AS-BUILT
SHIP CHECK 10/4/13

"R/V SIKULIAQ"

GENERAL ARRANGEMENT

0650-601-01

STERN VIEW
3/32"=1'-0"

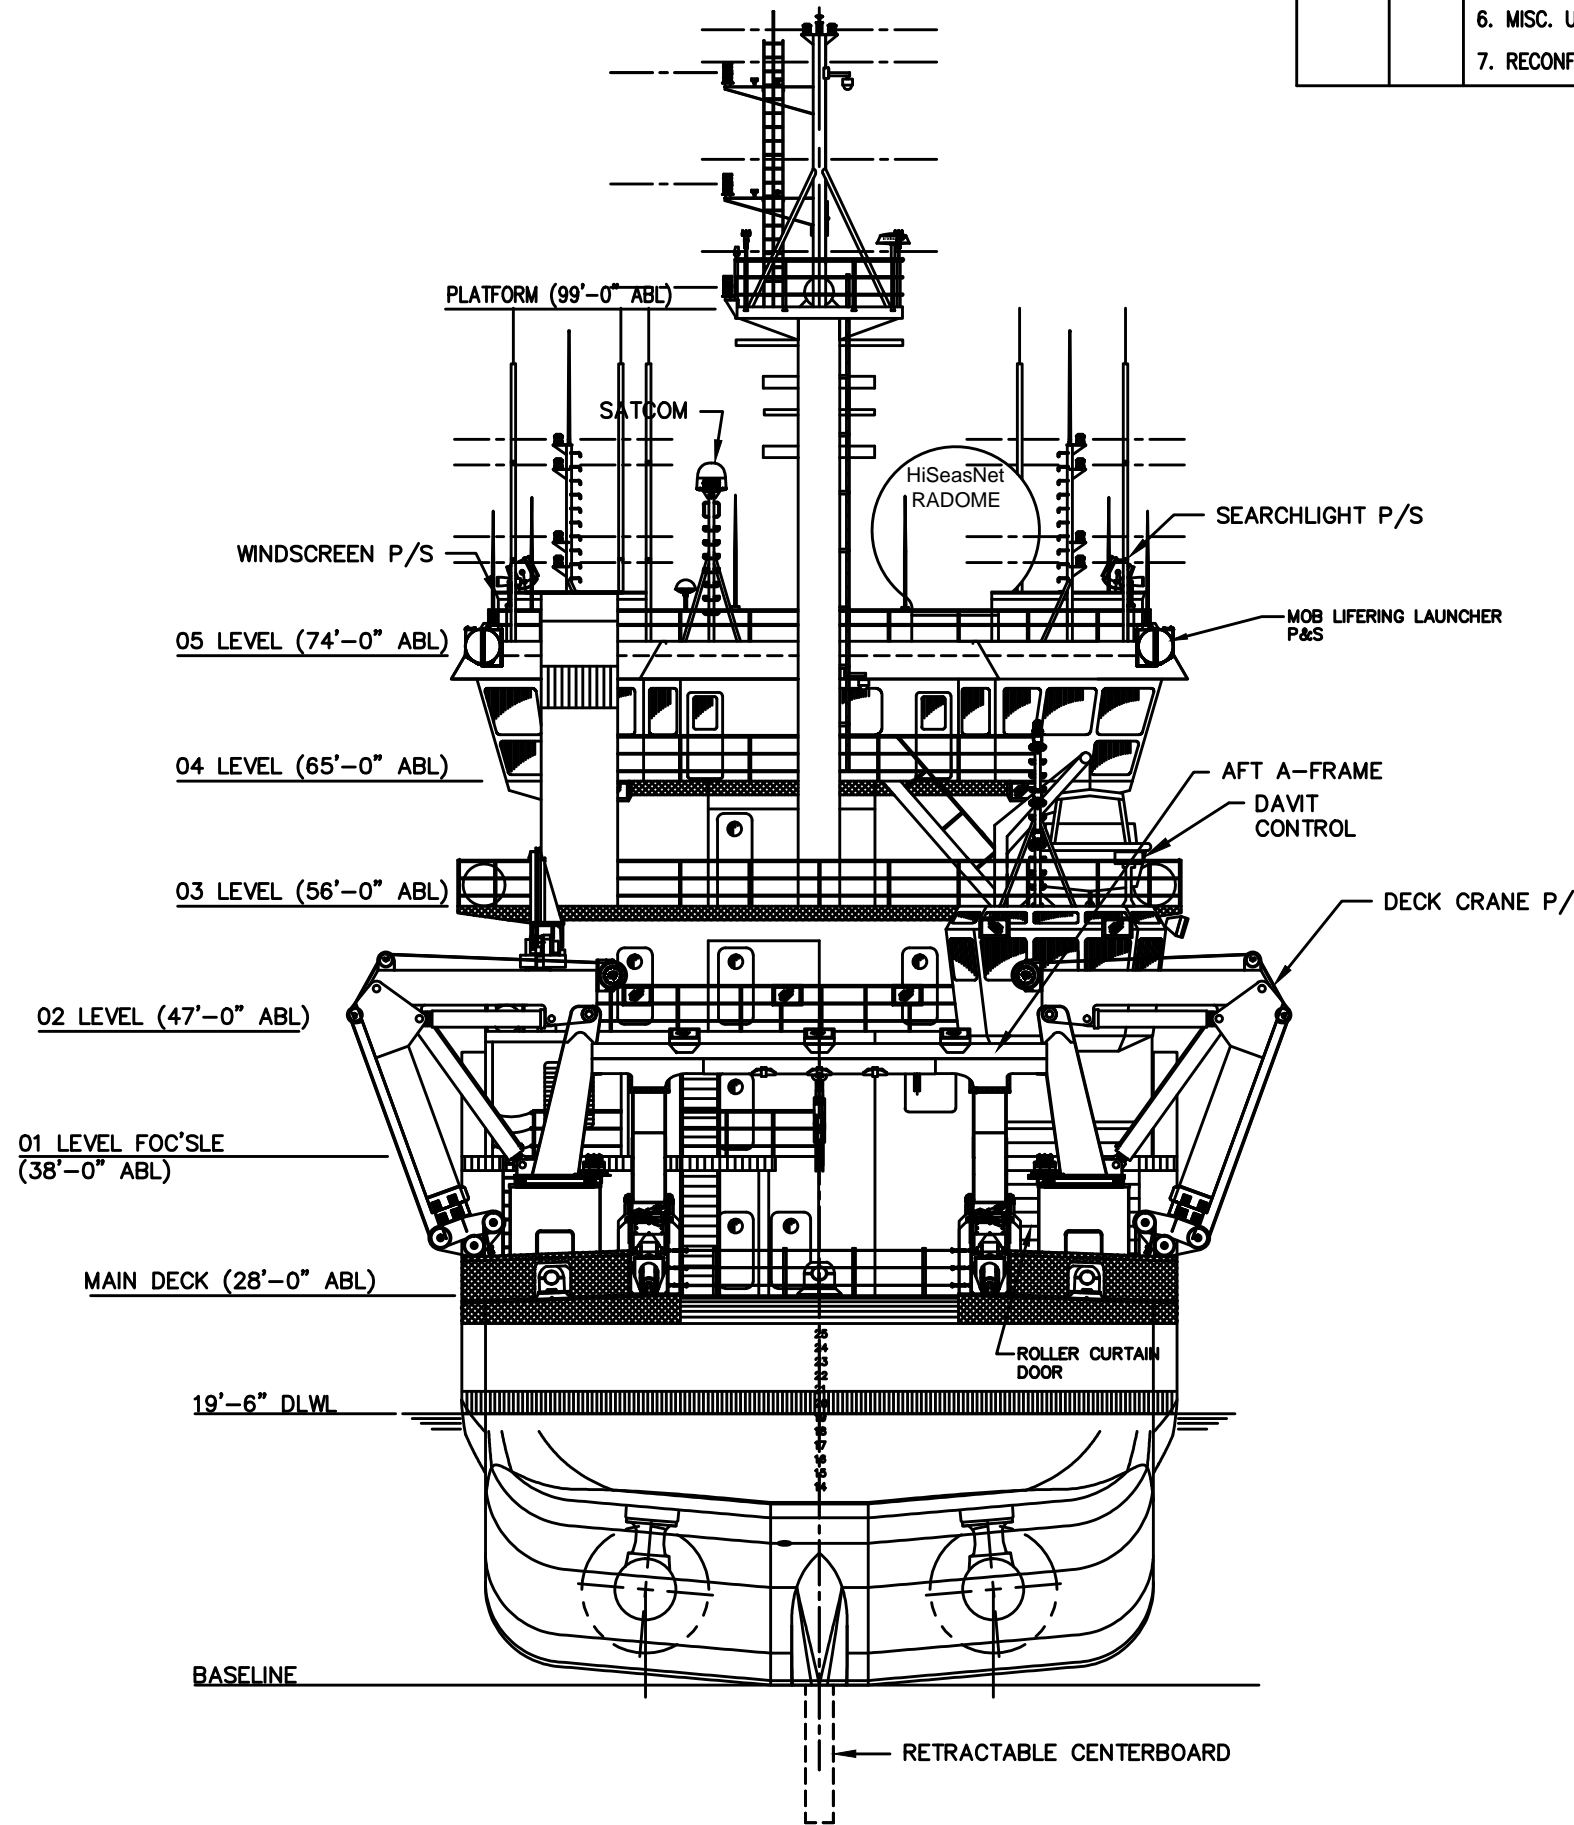
REVISIONS			
SHEET	REV.	DESCRIPTION	DATE
6	D	1. 01 LEVEL: REVERSED SWING OF DOOR 01-16-2 FROM LH TO LHR; REVERSED SWING OF DOOR 01-54-4 FROM RH TO RHR. REVISED PER ABS COMMENT L023.	01/21/13
1,2,3		2. MODIFIED 05 LEVEL VISOR AND WINDSCREEN TO SUIT DESIGN DEVELOPMENT. DESIGN HISTORY 67.	
5,6		3. DELETED CALLOUT FOR PASSAGE 1-15-1 AND ADDED SPACE DESIGNATIONS FOR THE CRANE PEDESTALS ON MAIN DECK, ALL PER UAF COMMENTS.	
7B,13B 45B,45C 2,3,5 6,7,8 4B,5B 11C,51B 2,3,7 20C,52D		4. CORRECTED BALTIC RM ROLLER DOOR CONFIGURATION TO SHOW MECHANISM INSIDE SPACE.

5. MODIFIED HANDRAILS THROUGHOUT AND REVISED MAST TO SUIT DESIGN DEVELOPMENT.	
		6. ADDED SIDELIGHTS FR. 13 ON 02 LEVEL PER DH-072.	
		7. RECONFIGURED BOATS AND DAVITS TO DEPICT ACTUAL MODELS PROVIDED.

8. ADDED ACCESS DOOR TO HVAC SPACE 03-27-1 PER DESIGN DEVELOPMENT AND DH-068.	
47B 3,6		9. RE-DESIGNATED SOFT PATCHES TWO STERN THRUSTERS AS WERP'S.	
2		10. ADDED MOORING LINE STORAGE REELS IN 01-(-10)-0 AND 1-75-2 PER DESIGN DEVELOPMENT.

11. REVISED HULL AESTHETIC STRIPING AND SPECIAL MARKINGS TO AGREE WITH THE PAINT SCHEDULE.	
REV D CONTINUED ON SHEET 2

OUTBOARD PROFILE
3/32"=1'-0"

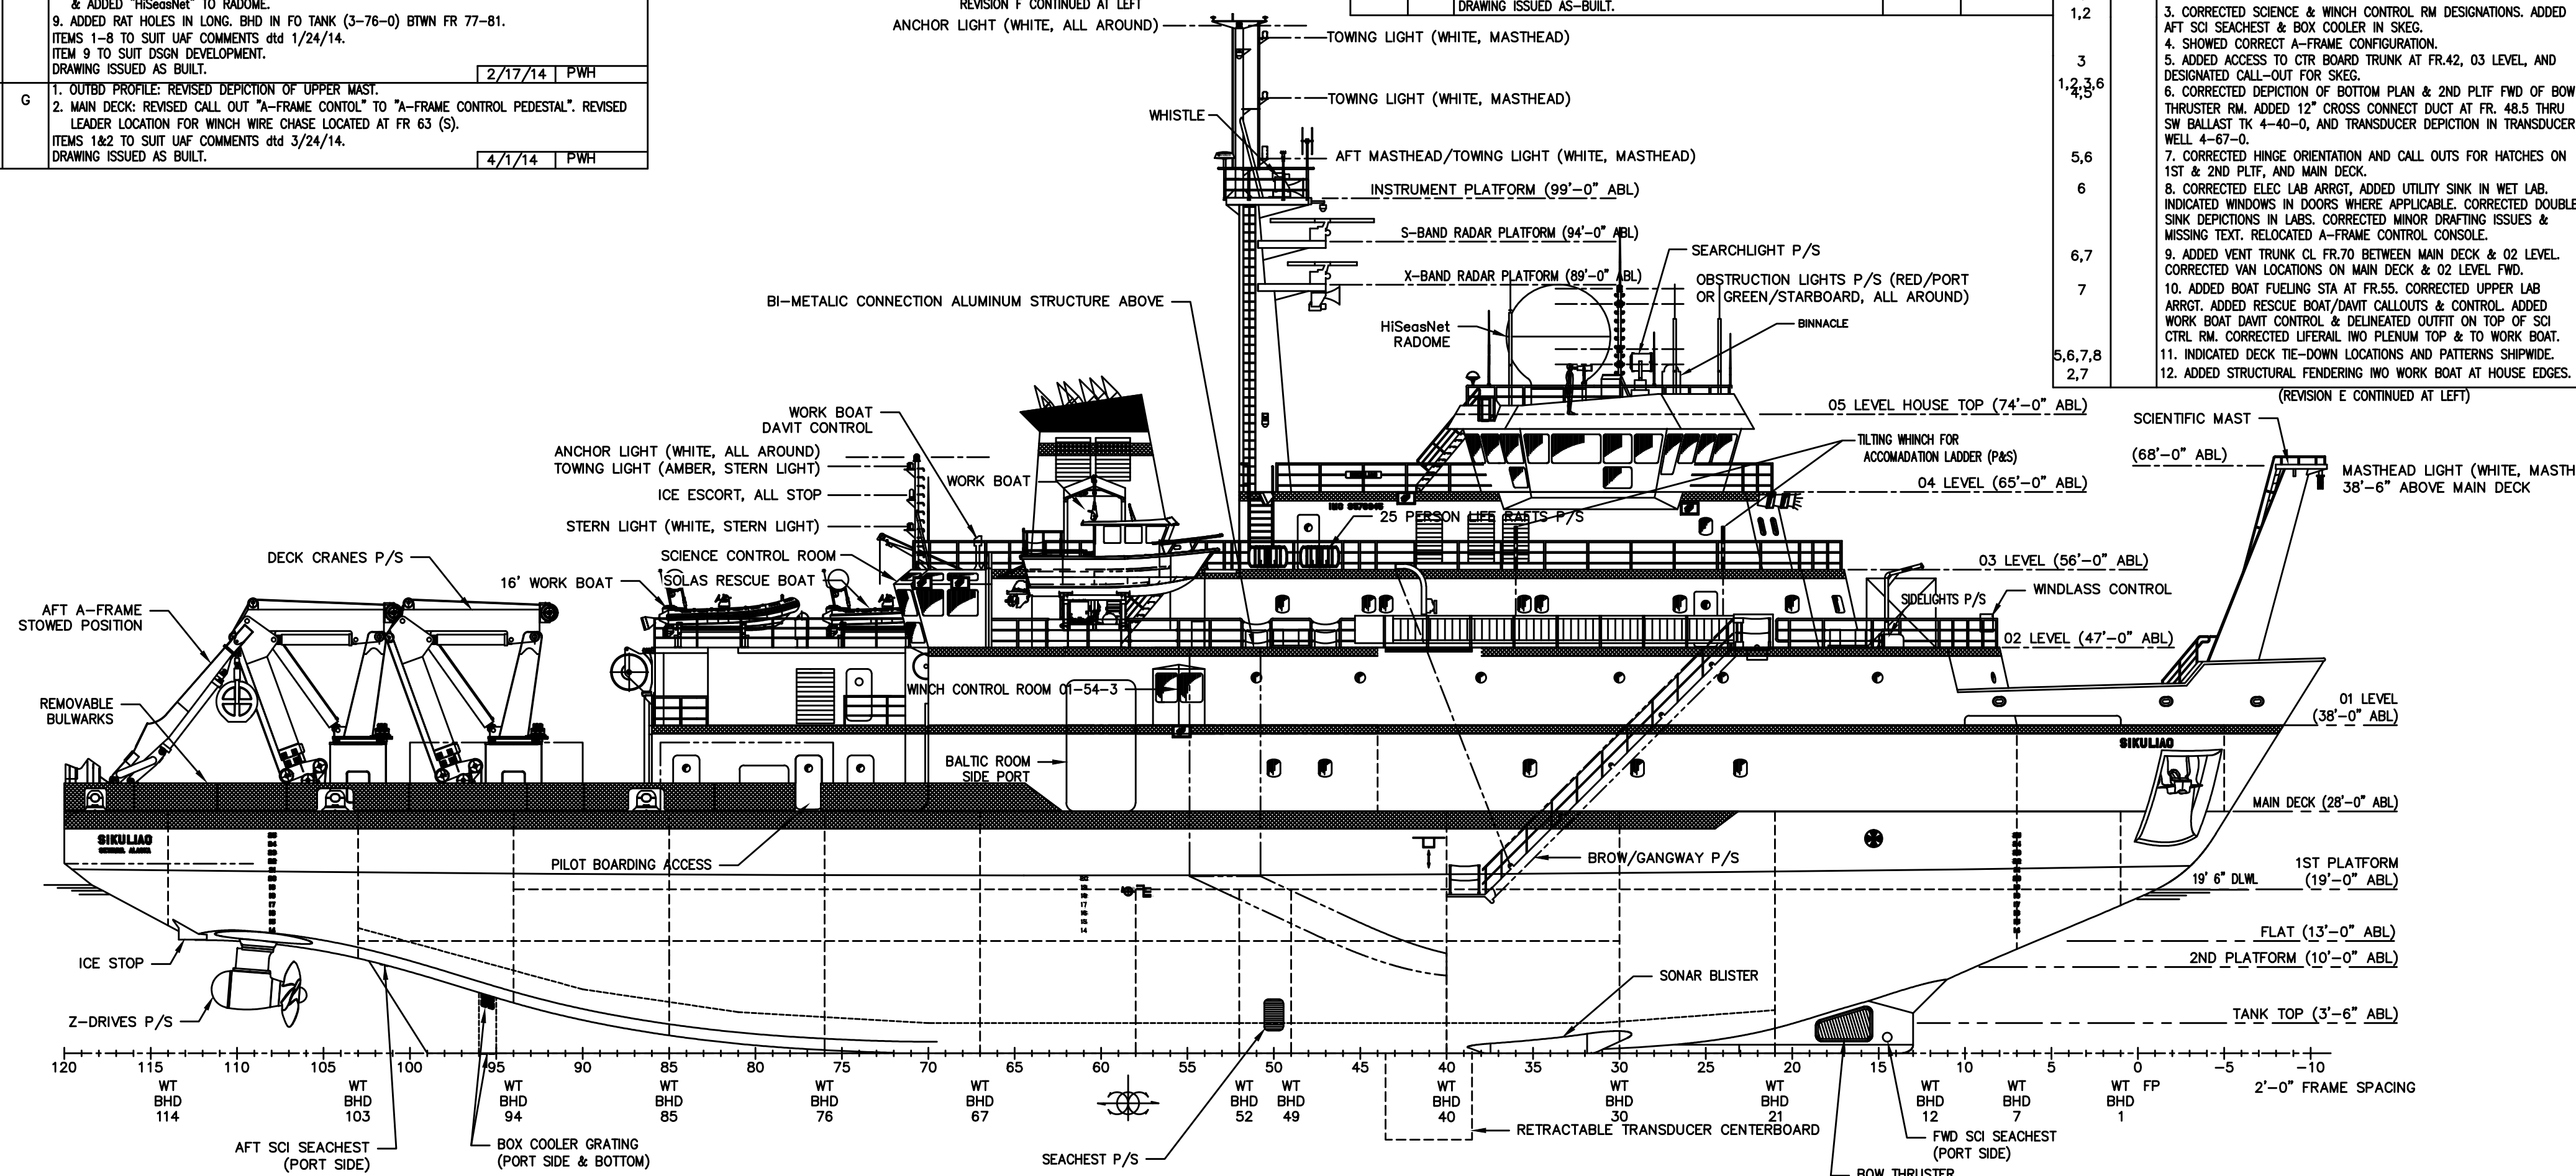
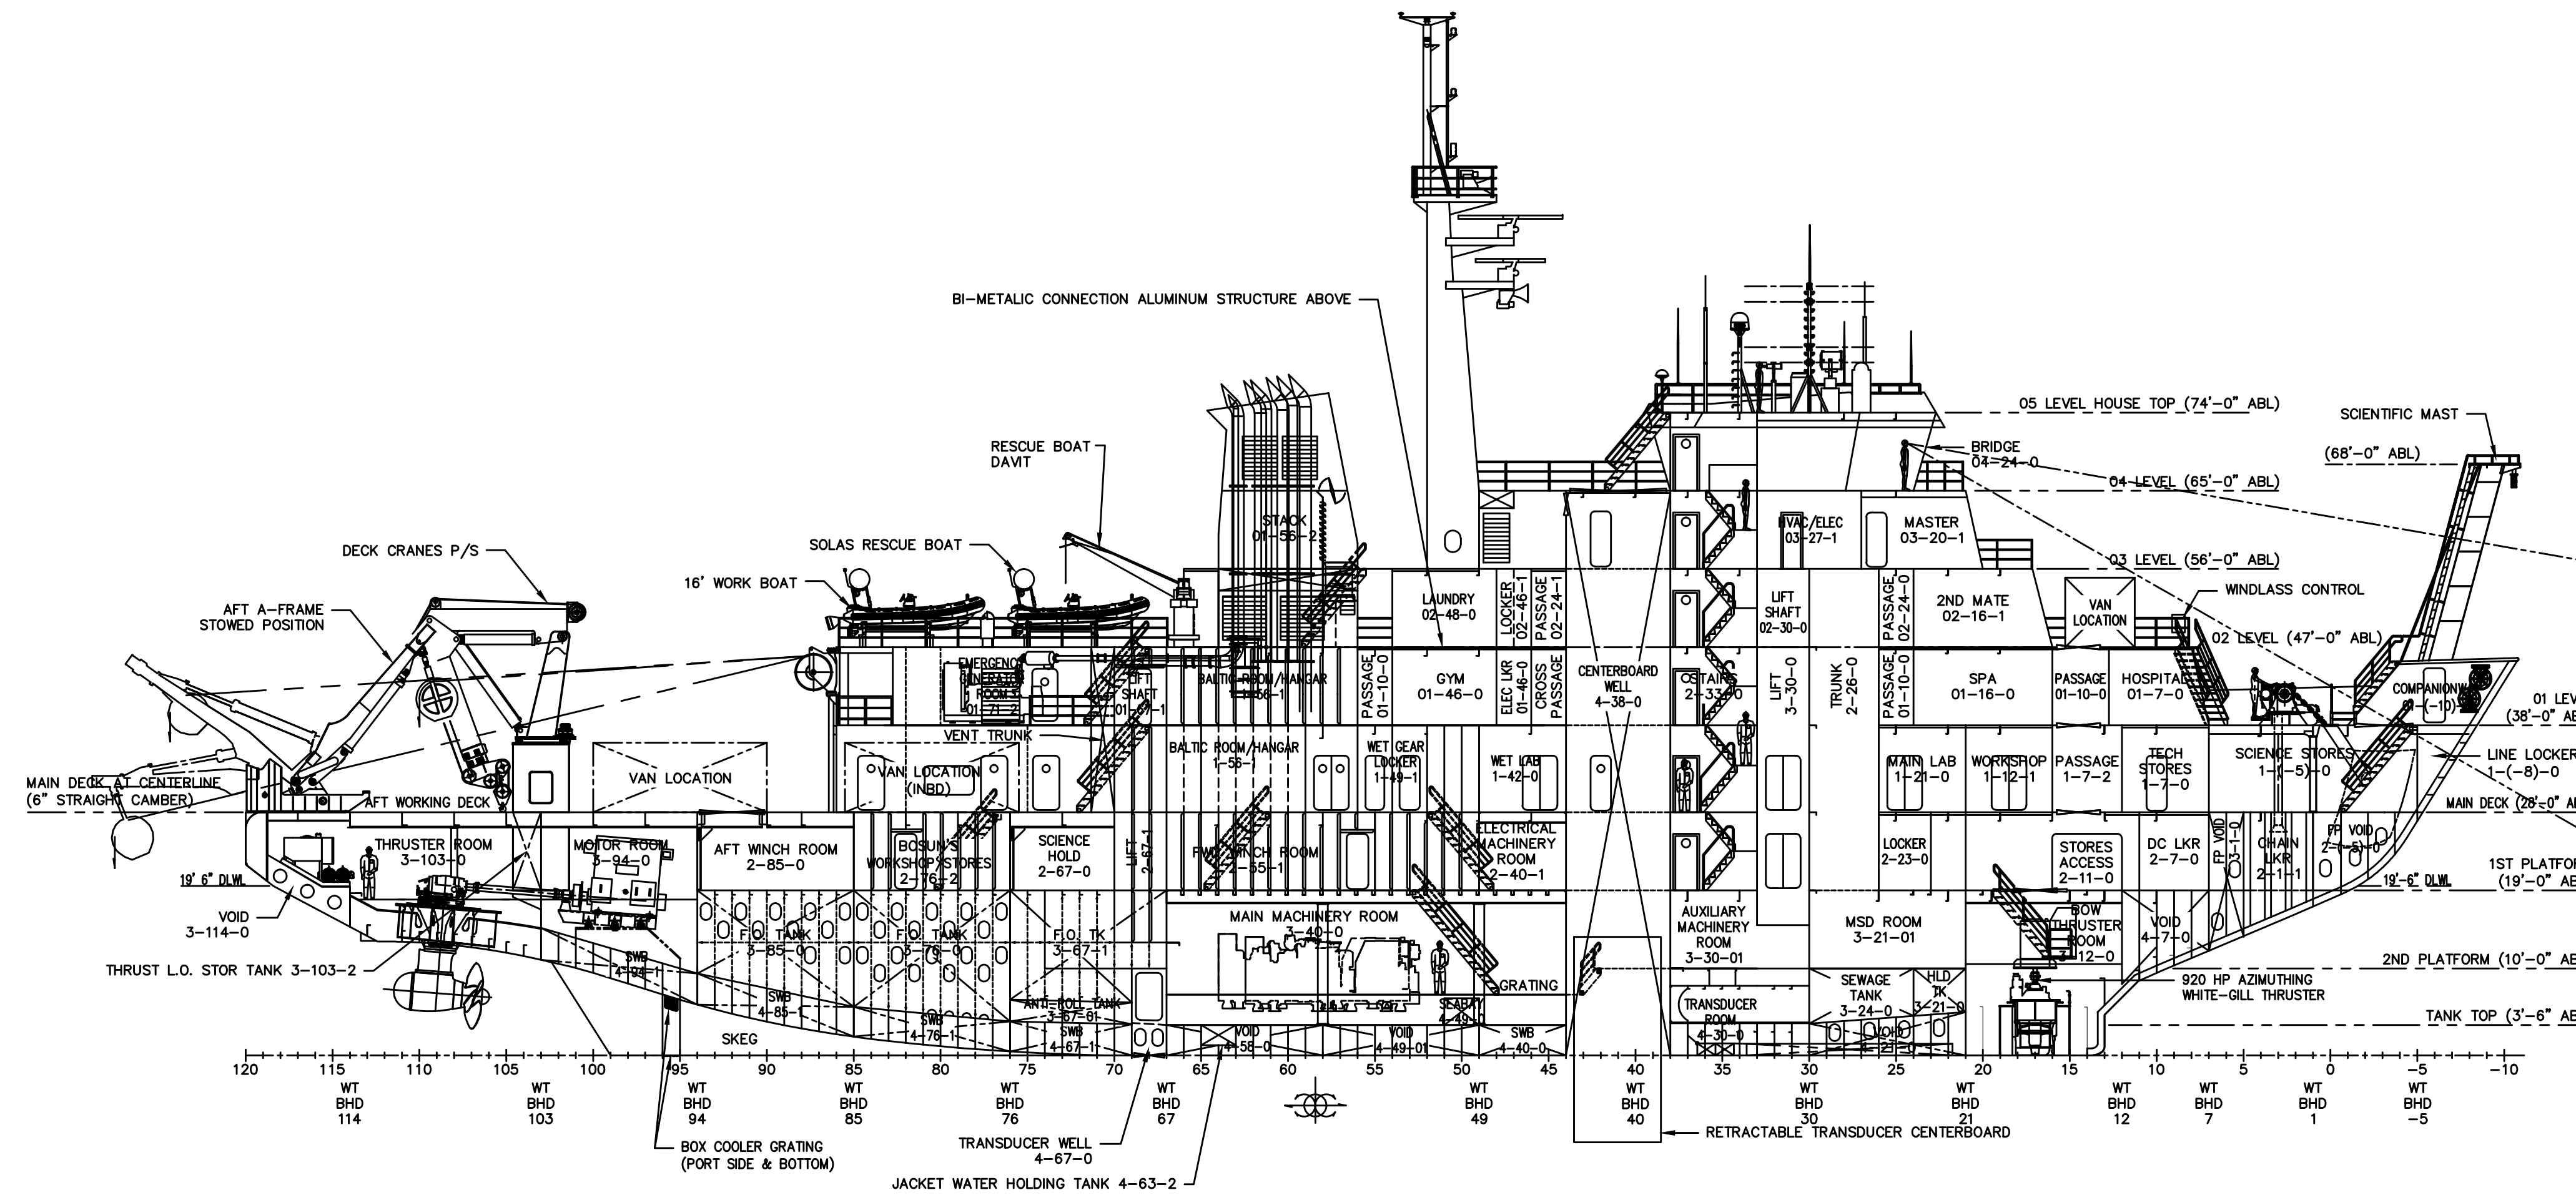
2	G	1. OUTBOARD PROFILE: REVISED DEPICTION OF UPPER MAST. 2. MAIN DECK: REVISED CALL OUT "A-FRAME CONTROL" TO "A-FRAME CONTROL PEDESTAL". REVISED LEADER LOCATION FOR WINCH WIRE CHASE LOCATION AT FR 63 (S). ITEMS 1&2 TO SUIT UAF COMMENTS dtd 3/24/14. DRAWING ISSUED AS BUILT.	4/1/14	PWH	<div>REVISION F CONTINUED AT LEFT</div> <div>ANCHOR LIGHT (WHITE, ALL AROUND)</div> <div>TOWING LIGHT (WHITE, MASTHEAD)</div> <div>WHISTLE</div> <div>TOWING LIGHT (WHITE, MASTHEAD)</div> <div>AFT MASTHEAD/TOWING LIGHT (WHITE, MASTHEAD)</div>
